### **Board or Commission: Conservation Commission**

**Date and Time of Meeting: Wednesday August 19, 2020 at 7.00 P. M**

Conservation Commission Meeting

Meeting Minutes

Disc Golf

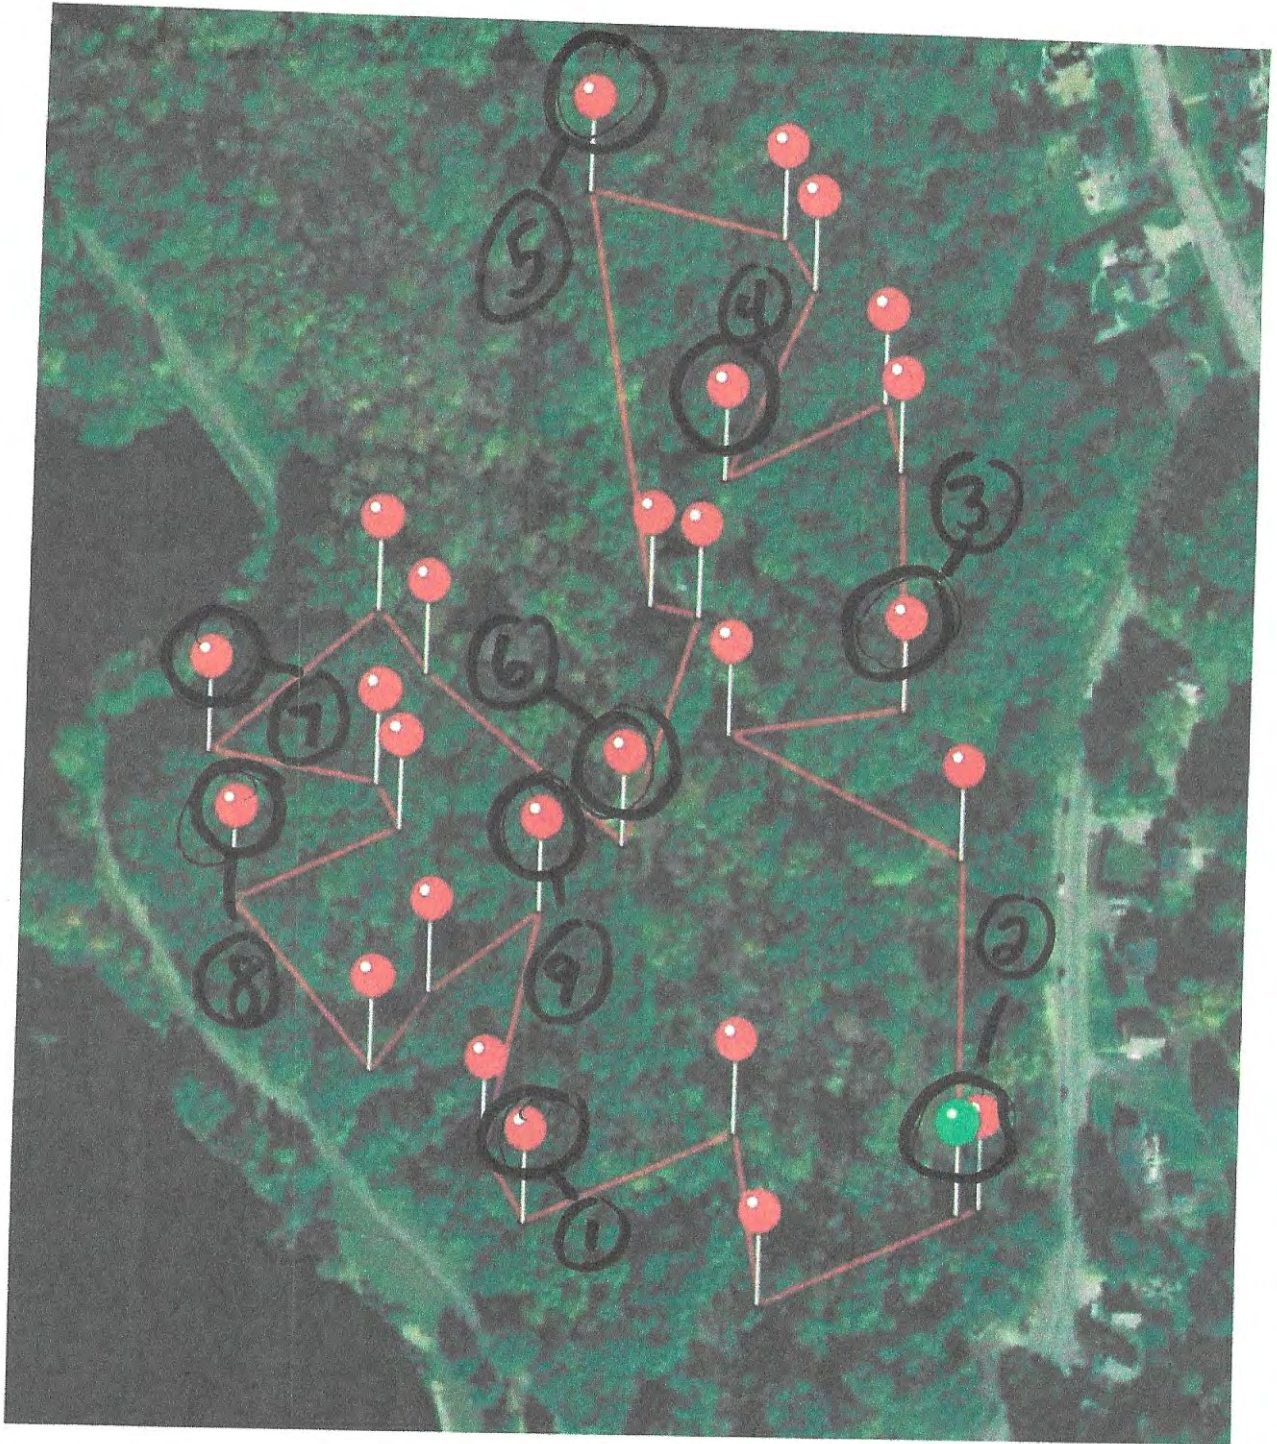
After the site visit and walk through of the proposed disc golf area I noticed that there are several areas that are populated with plants that are on the Massachusetts Invasive Species list and should be removed.

Removal of these trees and plants and other species will not cause any harm to the area and will help to create a diverse population of native plant material which would be considered a good management practice.

With that being said, as tree warden, I have no issues with the proposed project as it will be a great asset to the town.

SEPTIC SYSTEM DESIGN  
 PLAN OF LAND  
**LOT 9 GORDON DR**  
 IN  
**MILFORD, MA**  
 SCALE: 20 FEET TO AN INCH  
 DATE: AUGUST 3, 2020

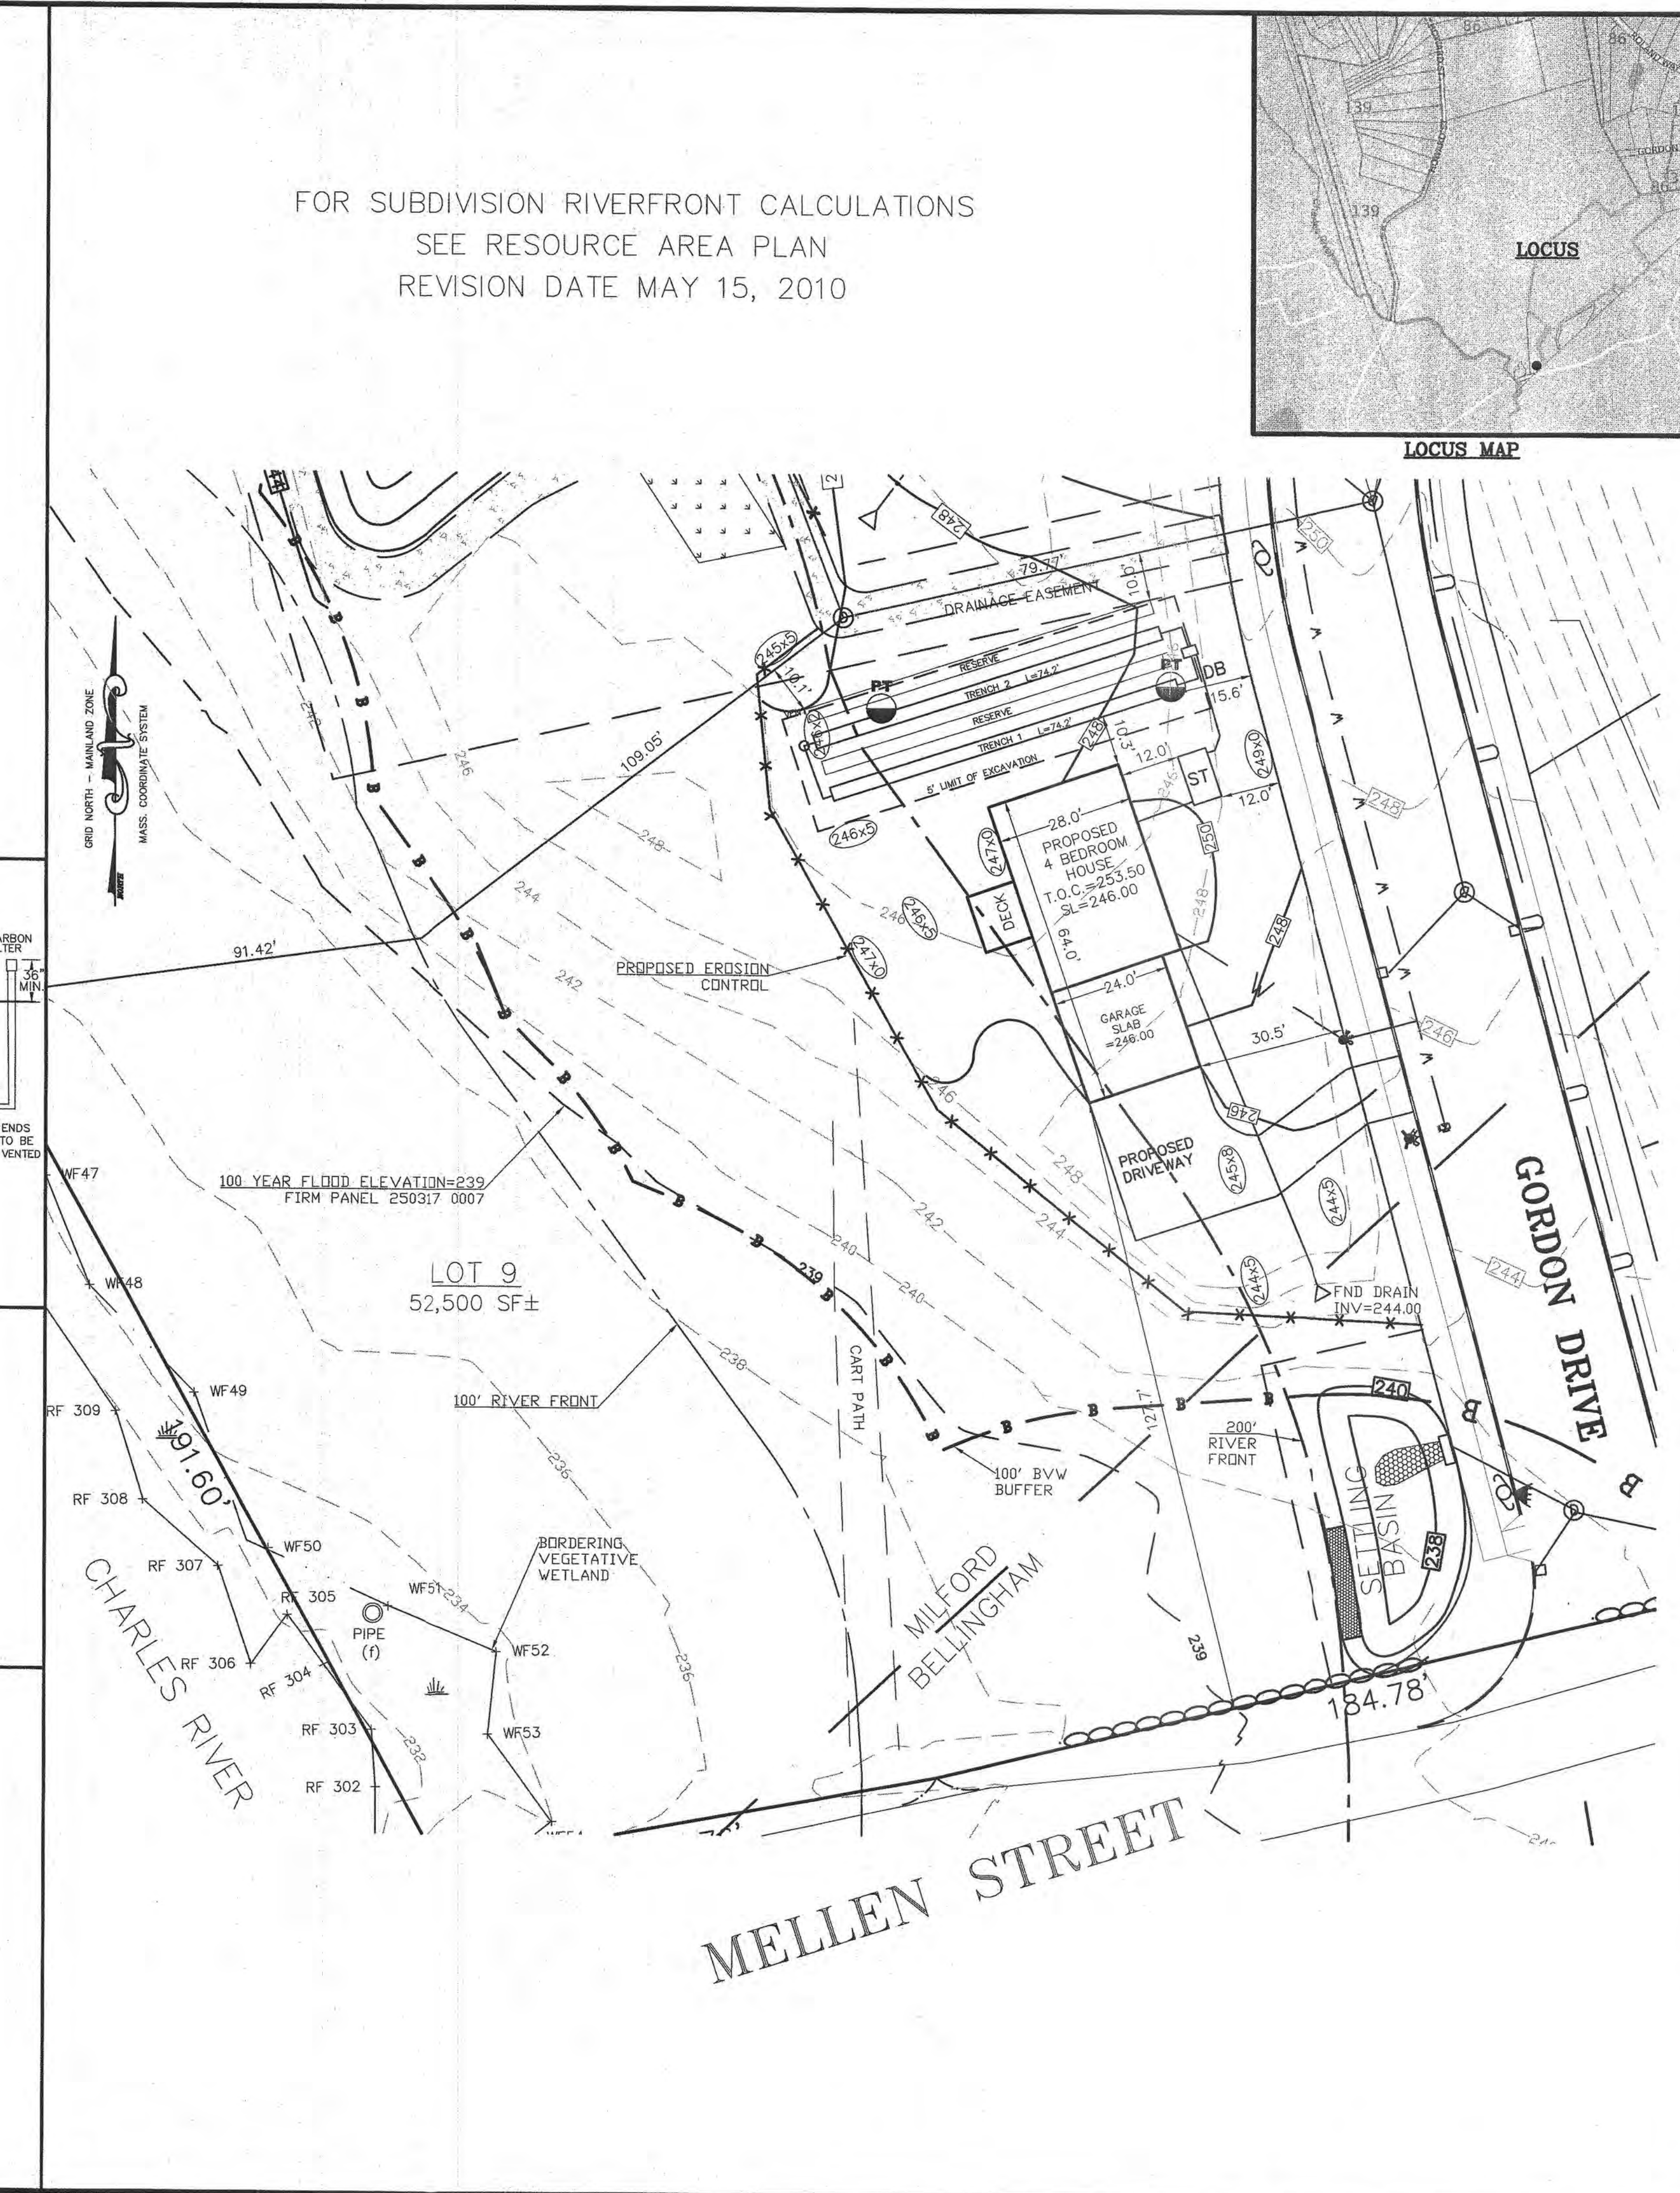
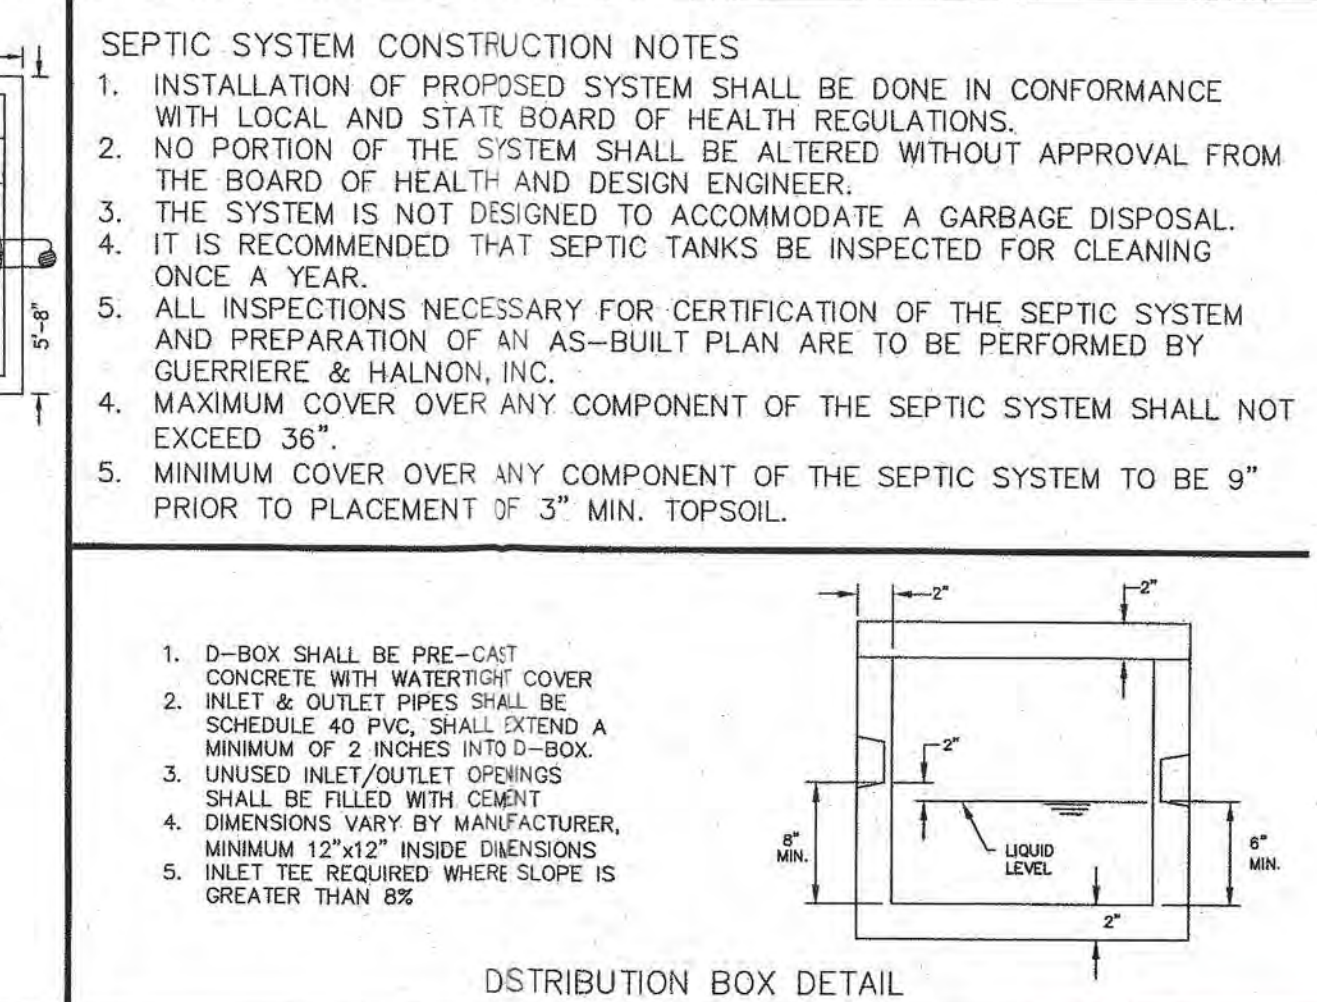
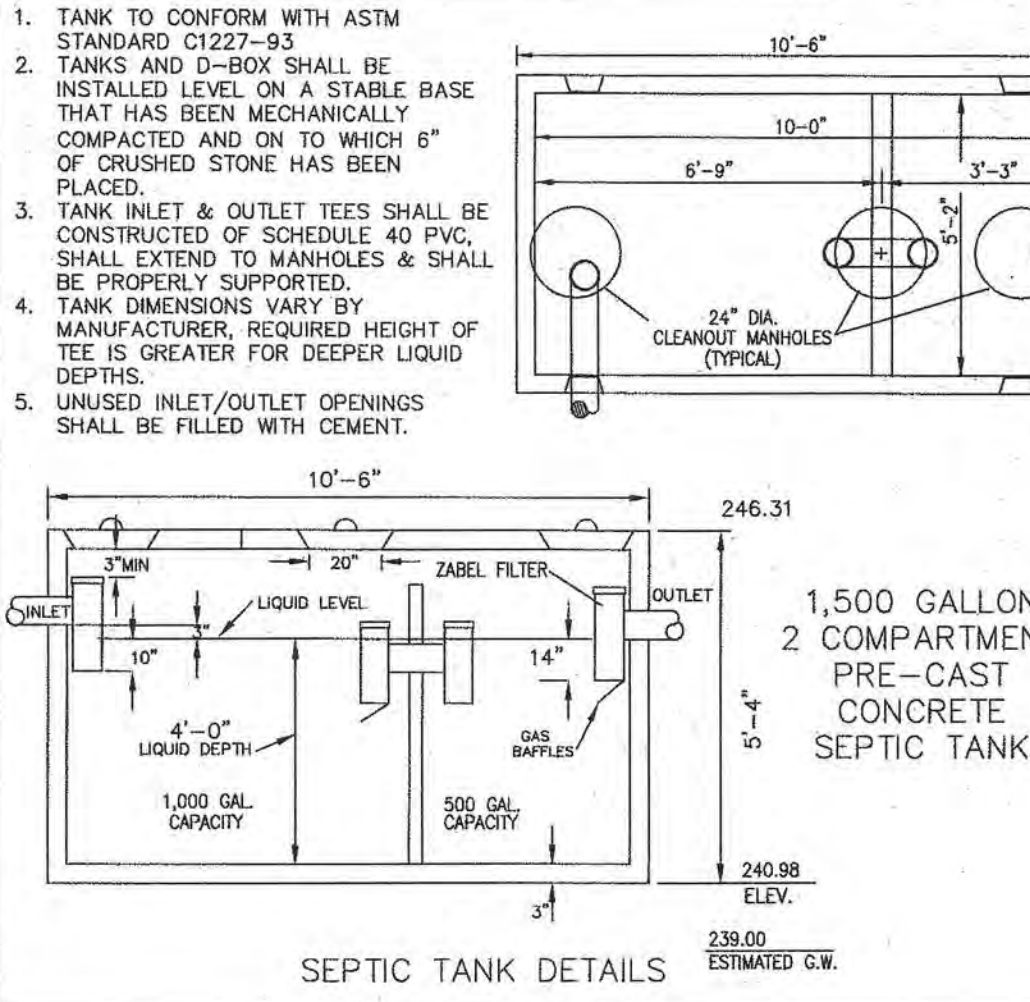
1. Construction of this lot has already started, there must have been some type of oversight, however there is only a small portion of proposed work that falls within the 100-foot buffer zone. This is a small area of grading associated with the Septic System.
2. The plan should show erosion control information.
3. The plan should clearly label the Riverfront Area, however no proposed construction of Lot 10 impacts the Riverfront Area.

4. The original Order of Conditions for the subdivision, DEP File # 223-1016, condition # 29 requires concrete bounds to be set every 50-feet along the outer riparian zone, (200-feet from the Charles River) and a Restoration of a portion of River Front Area. This proposed work should be shown on the submitted plan and referenced back to the original OOC / DEP File #.

I recommend the applicant address the original permit that was issued for the overall development DEP File # 223-1016, prior to approving the current submittal of lot 9.
